Licensee's Post Written Examination Comments and NRC Resolutions

Comments on Indian Point 2 July 2010 Initial NRC License Examination

Caruso, John

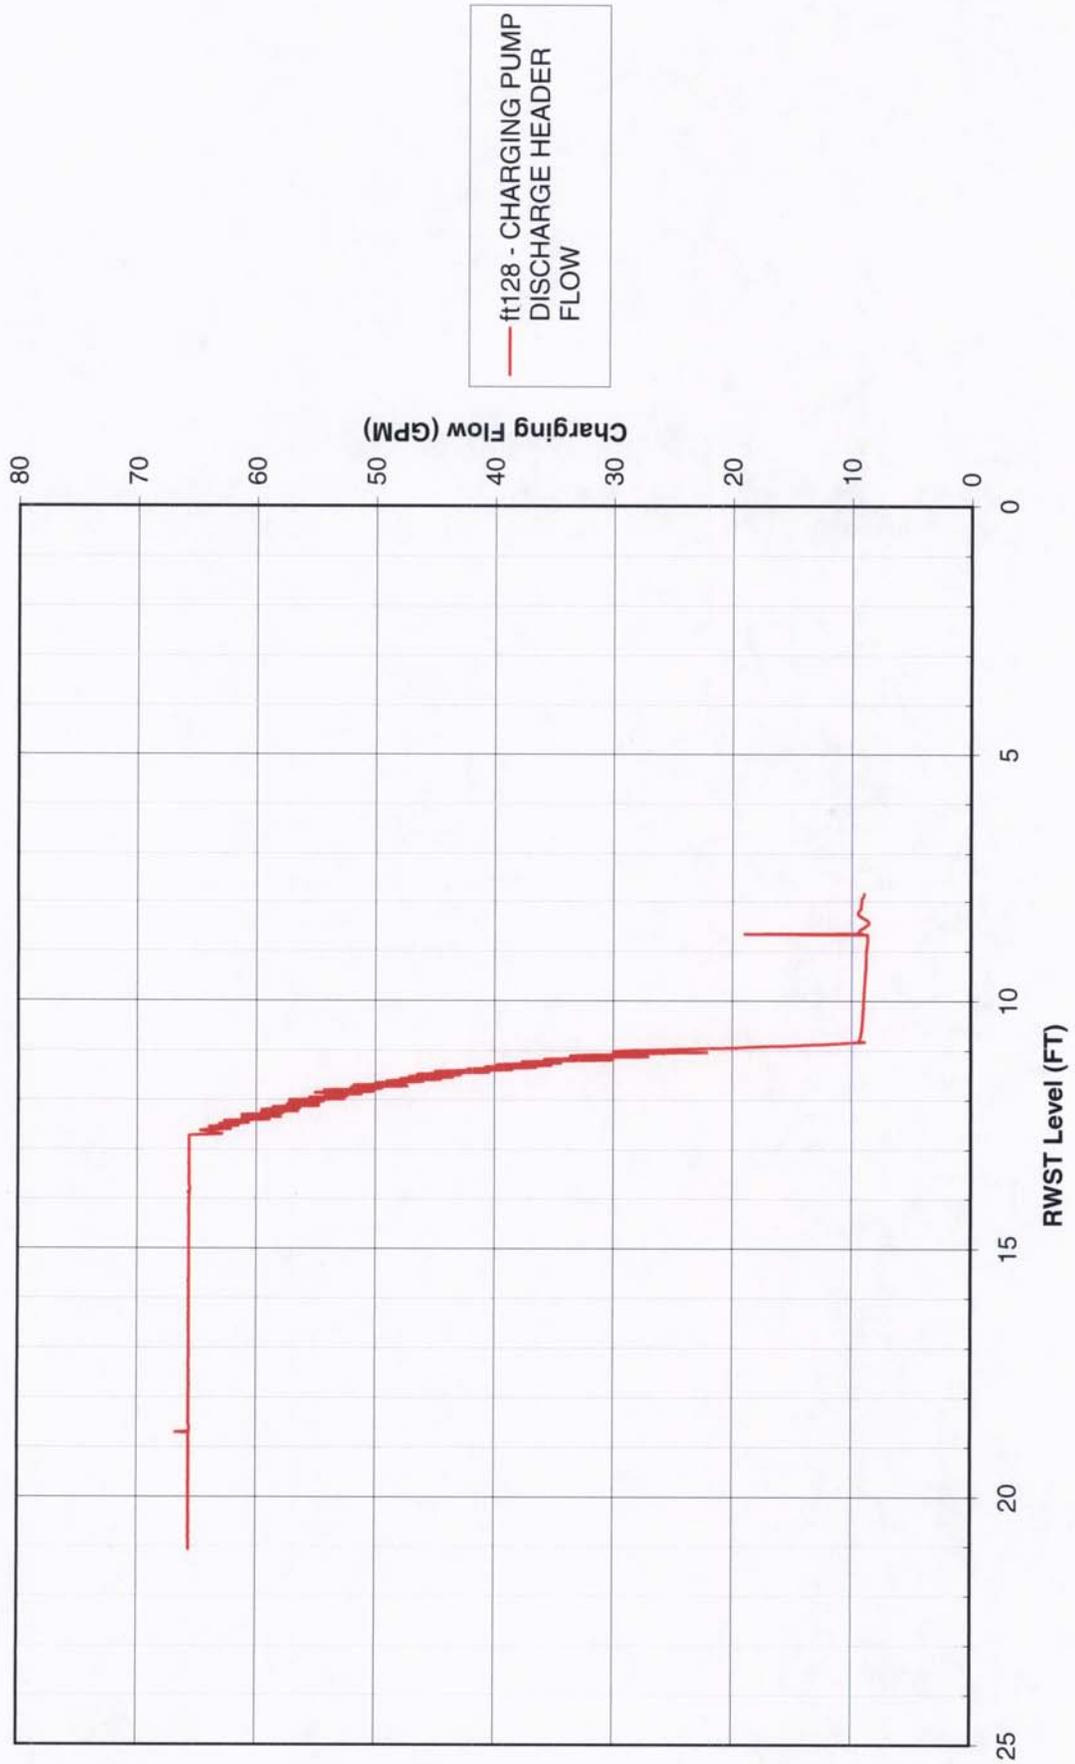
IPEC disagrees with the answer key that Answer B (22 Charging Pump prior to manipulating Recirc Switches in ES-1.3, Transfer to Cold Leg Recirculation) is the correct answer. Although the charging pump could be secured first, it would be secured in 2-E-1, prior to entering 2-ES-1.3 for the following reasons:

- Page 9 of 2-E-1 contains a CAUTION that states “If RWST level decreases to less than 15 ft. charging pumps that are started or running should be monitored for loss of suction which may result in pump damage.” In the IPEC Unit 2 Simulator the candidates have observed that charging flow begins decreasing when RWST level lowers to 12 ft, with charging flow significantly reduced by the time that RWST level reaches 11 ft. The operators have been trained to secure the charging pumps when they observe charging pump flow decreasing due to loss of suction. During initial charging pump operation starting in 2-E-0, the charging pump is placed in service at maximum speed with charging flow at approximately 65 gpm. Data taken during LBLOCA in the Unit 2 simulator supports that charging pump discharge flow drops significantly (see attached). When RWST level reaches approximately 12.7’, flow is observed to begin lowering with the charging pump still at maximum speed. At approximately 10’ in the RWST, flow has lowered to 9 gpm. Operators are trained to secure a piece of running equipment when its suction source is lost.

- Answer B does not correctly identify the procedural guidance for securing the charging pump. Although Step 4 of 2-ES-1.3 stops all charging pumps to reduce 480V bus loads, the charging pumps would already be secured in 2-E-1 when RWST level lowered to less than 12 ft but prior to transitioning to 2-ES-1.3 at 9.24 ft.

The NRC position is that "B" answer would always be a correct answer based on the procedural guidance alone: 1) The procedural guidance in 2-E-1, Page 9, CAUTION that states "If RWST level decreases to less than 15 ft. charging pumps that are started or running should be monitored for loss of suction which may result in pump damage." However, this guidance does not provide explicit direction to secure the charging pump(s) based on this caution and in some cases it may be desirable to maintain the pump(s) running as long as possible; 2) In contrast, 2-ES-1.3 does provide explicit guidance on when the charging pumps must be secured. The CAUTION just prior to step 4 states, "Any pumps taking suction from RWST should be stopped if RWST level decreases to 3.0 ft for SI and charging pumps....";

3) 2-ES-1.3, step 4, provides further direction to stop all charging pumps and this is done prior to performing procedural step 6, "Place Safety Injection Recirc Switches 1 AND 3 to ON" that provides the bases for selecting answer choices "C" or "D". The question stem asks which of the following pumps could be secured first, answer choice "B" states, "22 Charging Pump prior to manipulating Recirc Switches in ES-1.3, Transfer to Cold Leg Recirculation". The licensee has provided justification for stating charging pumps may be secured earlier using the guidance in 2-E-1. Given a LBLOCA condition, the charging pumps will always be secured first in the sequence whether using the guidance in 2-E-1 or by using the guidance contained in 2-ES-1.3. Finally, if for any reason the charging pumps are not secured prior to entering procedure 2-ES-1.3 then this procedure directs that the charging pump(s) would be secured prior to taking the action in procedure step 6 that provides the basis for selecting answer choice "C" or "D". The NRC disagrees that key answer B is incorrect.

The question stem asks the candidates to determine two things: 1) which pumps could be secured first, and 2) what is the procedural guidance for this action [securing the pumps]? The NRC concludes that answer "C" (22 SI Pump from Recirc Switch 1 in ES-1.3, Transfer to Cold Leg Recirculation) should also be accepted as a correct answer for the following reasons: 1) The procedural guidance in 2-E-1, Page 9, CAUTION states "If RWST level decreases to less than 15 ft. charging pumps that are started or running should be monitored for loss of suction which may result in pump damage." In addition, the 2-E-1 Background document, page 56, basis section indicates that a section of the charging pump suction piping is at an elevation of 15 feet above the bottom of the Refueling Water Storage Tank (RWST). If RWST level decreases to less than 15 feet a vacuum will be drawn in that section of the piping that may cause a decrease or loss of charging pump suction pressure and flow; 2) The operators have been trained to secure the charging pumps when they observe charging pump flow decreasing significantly due to loss of suction in order to protect plant equipment; and 3) The Unit 2 simulator data provided by the licensee for Large Break Loss of Coolant Accident (LBLOCA) indicates that charging pump discharge flow drops significantly when RWST level lowered to less than 12 feet. 4) Transitioning to 2-ES-1.3 is not done until level in the RWST level decreases to less than 9.24 ft. Therefore, based on guidance in 2-E-1, the simulator data and training provided to the operators, it is conceivable that the operators would be expected to secure any running charging pumps prior to transitioning to procedure 2-ES1.3 (i.e., especially since all other systems are operating normally as the stem of the question indicates. It follows then that if charging pumps are secured earlier in 2-E-1 for all of the reasons stated above (i.e., prior to transitioning to 2-ES1.3) then 22 SI pump could be the first pump secured in 2-ES-1.3.

The NRC has determined that in both cases noted above the applicant could transition to 2-ES-1.3 by appropriately using the station procedures and cautions. The result is that the charging pumps could be on or off depending upon the use of the caution step in 2-E-1, prior to entering 2-ES-1.3, which could lead to either answer B or C being correct.
